# MONA OFFSHORE WIND PROJECT

## Response to Griff Parry on behalf of Harriet Mary Parry, Robert Wynne Parry, Griffith Wynne Parry and Elizabeth Wynne Wade D2 Submission

Document Reference: S\_D3\_8

Table 2.1: REP2-102 - Griff Parry on behalf of Harriet Mary Parry, Robert Wynne Parry, Griffith Wynne Parry and Elizabeth Wynne Wade

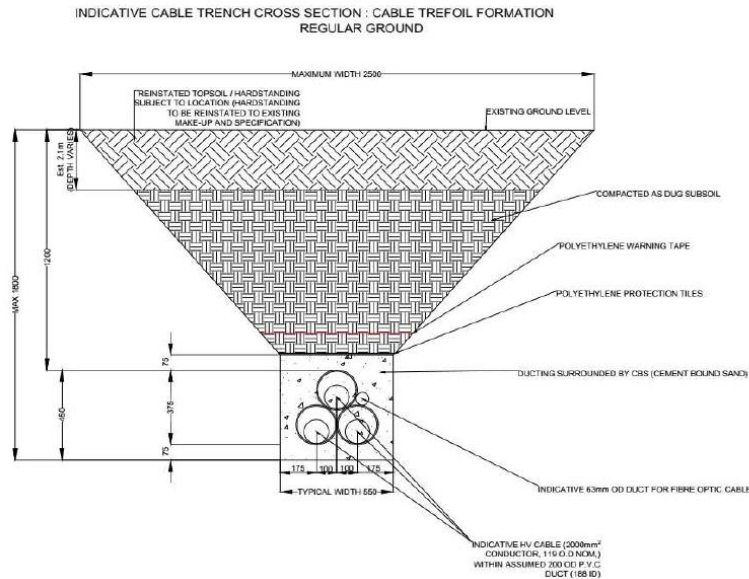
REP2-102.6	2.6 This supplementary written submission seeks to review the Promoter's now proposed working area shown in the cross section on the Drawing, firstly from a temporary construction point of view and secondly from the impacts that these methods have on the permanent sterilising land rights.
REP2-102.7	2.7 It should be read in conjunction with section 12 of the August 7th Submissions which it expands from a more practical / hands on approach.
REP2-102.8	2.8 It considers each constituent part of the cross section, soil storage bunds, trench widths, separation strip widths, haul road widths from thermal, electromagnetic, construction and maintenance / repair perspectives.
REP2-102.9	3.0 <b>Construction and Maintenance Methodology.</b> 3.1 With the exception of watercourses and hedges, the Promoter proposes open trench excavation over the Plots. They propose laying 4 no. trenches over the approximately 345 linear meters of the Plots.

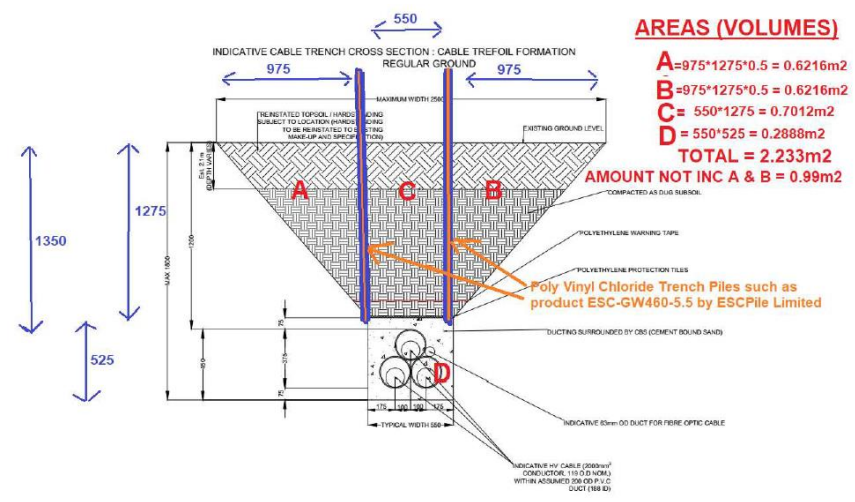
REP2-102.15 3.7 The drawing is clearly marked “not to scale” and so the Promoters proposed angulation for the excavation cannot be reliably measured. There also seem to be some discrepancies with the Promoter’s vertical measurements on the diagram which make calculating the angle a little more difficult. Nevertheless, with some margin for error, the angle has been estimated to be approximately 52.5 degrees from the horizontal.

REP2-102.17 3.9 Nevertheless, based on the standard arrangement described in the Hearing Action Point Submission, it can be seen that after the first 1.275m of the trench walls will be battered at an angle of approximately 52.5 degrees. This causes the open trench

area to extend to a width equating to an additional 1.95m over what is strictly necessary to accommodate the cables which is namely the 0.55m at the very bottom of the trench with the angulation entirely unnecessary.

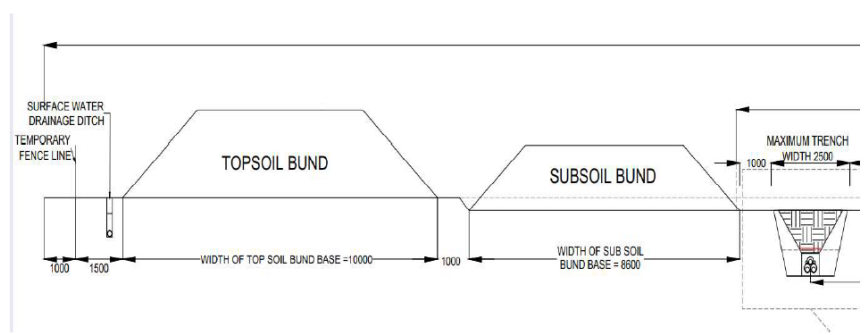
REP2-102.18 3.10 Notwithstanding the health and safety risks, this gives rise to a great deal of additional excavation and material arisings than would otherwise be required and this is calculated in the markup below:

REP2-102.19 3.11 Areas A,B,C and D amount to approximately 2.233m<sup>2</sup>. For each linear metre of the cables the volume of spoil being removed would therefore be 2.233m<sup>3</sup>.

REP2-102.23	3.15 The total excavation area of the cross sectional area is therefore 2.233m <sup>2</sup> . For a 1m linear length of trench this would be a volume of 2.233m <sup>3</sup> . Depending on material type and moisture, or water content, at the time, it would be expected that this would weigh in the region of 3.5 tonnes.	
REP2-102.24	3.16 For instance, for every individual linear metre of trench excavated in line with the current proposals then some 3.5 tonnes of material would be excavated by the Promoter or 14 tonnes overall for all 4 proposed trenches.	
REP2-102.25	3.17 Obviously this is for the settled (compacted) soil in situ in the ground. When excavated the weight would obviously stay the same but, due to the disturbance, the volume would increase and this can mean an increased volume by up to 40% in exceptional circumstances. The increased volume per linear metre of trench would therefore be 3.13m <sup>3</sup> (being 2.233m <sup>3</sup> *140%) or 12.5m <sup>3</sup> (being 2.233m <sup>3</sup> *4) over all 4 proposed trenches.

REP2-102.26	3.18 Areas A and B are obviously right angled triangles and their combined volume has been calculated to each be 1.2432m <sup>3</sup> (being, 0.6216m <sup>3</sup> *2) per linear meter of each individual trench or 1.7405m <sup>3</sup> (being, 1.2432m <sup>3</sup> *140%) once disturbed. Over the 4 trenches this would be 6.962m <sup>3</sup> (being, 1.7405m <sup>3</sup> *4) per linear meter.	
REP2-102.27	3.19 The Promoter's cross section Drawing in the Hearing Action Point Submission shows a 10 metre topsoil bund together with an 8.6 metre subsoil bund at both sides of the proposed trench excavations. No measurements are given for the bund heights and they cannot be scaled as the drawing clearly states that it is "not to scale"

The Applicant would emphasise that the cross sections provided at Deadline 1 (REP1-018) are indicative and state that they should not be

Reference	Written Submission Comment	Applicant's response
	3.14 For the following purposes we ignore any separation between topsoil and subsoil (which varies in depth from site to site in any event) and just deal with overall volumes.	<p>used for scaling. They have been provided to give an example of how the proposed trenches would be accommodated within the Onshore Cable Corridor. The proposed installation technique depicted on the cross sections provided is the industry standard for excavation of trenches and installation of a ducted system, for cross-country cable routes. The volume of soil to be excavated and stored at any specific location will depend on a number of factors including ground conditions and final location of joint bays and link boxes, all of which will be determined during detailed design.</p> <p>In addition, the calculations provided in the Representation do not fully assess all options presented within the Project Description (APP-050), for example, a flat formation will be up to three times the width at the base of the trench compared to the trefoil formation used in the calculations and will therefore require additional soil to be excavated.</p>

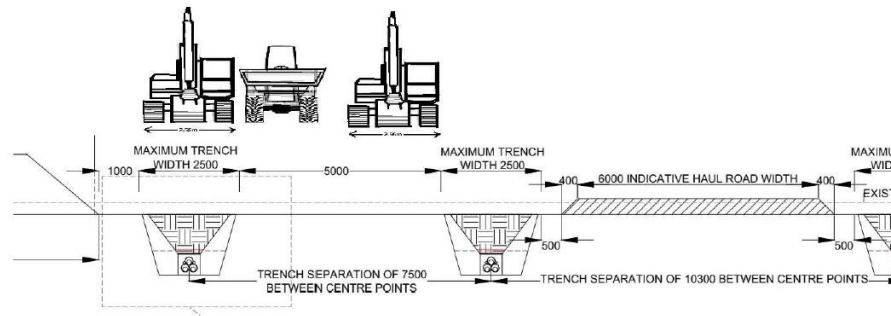
REP2-102.43	3.35 In terms of construction a standard 12 tonne tracked excavator has a width of approximately 2.55m wide. This itself is slightly more than the trench width that the Promoter intends to utilise.	<p>The Outline Highways Access Management Plan (APP-228) presents the access strategy for the Project. In order to minimise impacts of Heavy Goods Vehicle (HGV) traffic upon concentrations of sensitive receptors, the temporary construction haul road will be used where possible to avoid routeing traffic along the public highway network. Therefore, the</p>
REP2-102.44	3.36 Two excavators have therefore been shown overlaid on the Drawing below:

REP2-102.45 3.37 A tracked trenching excavator would ordinarily operate by locating itself on the line of the as yet unopened trench so that the jib was behind it and in line with the centre of the newly excavated trench to the rear of its direction of travel. The diagram shows that not only is there sufficient room for an excavator over the trench but that a further two excavators or more likely, 5 to 7 tonne dumpers (also of width circa 2.5m) or similar pieces of large excavation / muck removal equipment could be accommodated in the 5m spacing which as well is excessive and unnecessary for cable laying and accomplishment of the Scheme. This would be even more the case in the event that the narrower trenches were employed due to using more efficient and safer trench piles.

haul road is required to provide 2-way access predominantly for standard HGV movements along the entirety of the Onshore Cable Corridor.

The haul road has been indicatively shown centrally within the Onshore Cable Corridor, as shown on the indicative cross-section issued at Deadline 1 (REP1-018), as this approach minimises the amount of construction traffic movements on the subsoils and is typically used on other cross-country cable route projects. The haul road width and location within the cable corridor will be confirmed during the detailed design stage and will be influenced by topography and existing ground conditions.

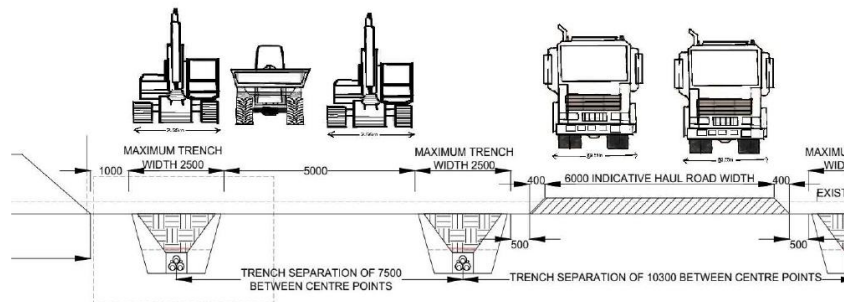
REP2-102.50 **6 metres haul road down the centre of the permanent easement area**  
3.42 A standard 4 axle rigid 32 tonne tipper also has a width of approximately 2.55m wide. This again itself is slightly more than the trench width that the Promoter intends to utilise.

REP2-102.51 3.43 Two such tipper wagons have therefore been shown overlaid to on an extract from Drawing below which shows that the road can conveniently accommodate two way Heavy Goods Vehicle traffic:

REP2-102.52 3.44 This convenience explains why the Promoter desires such a wide haul road the entire length of the onshore scheme even though the haul road would be extremely unlikely to be used again during the entire life of the cables once the scheme was implemented. Regardless of the fact that there would be no cables beneath the road, the Promoter still intends to sterilise this land as well.
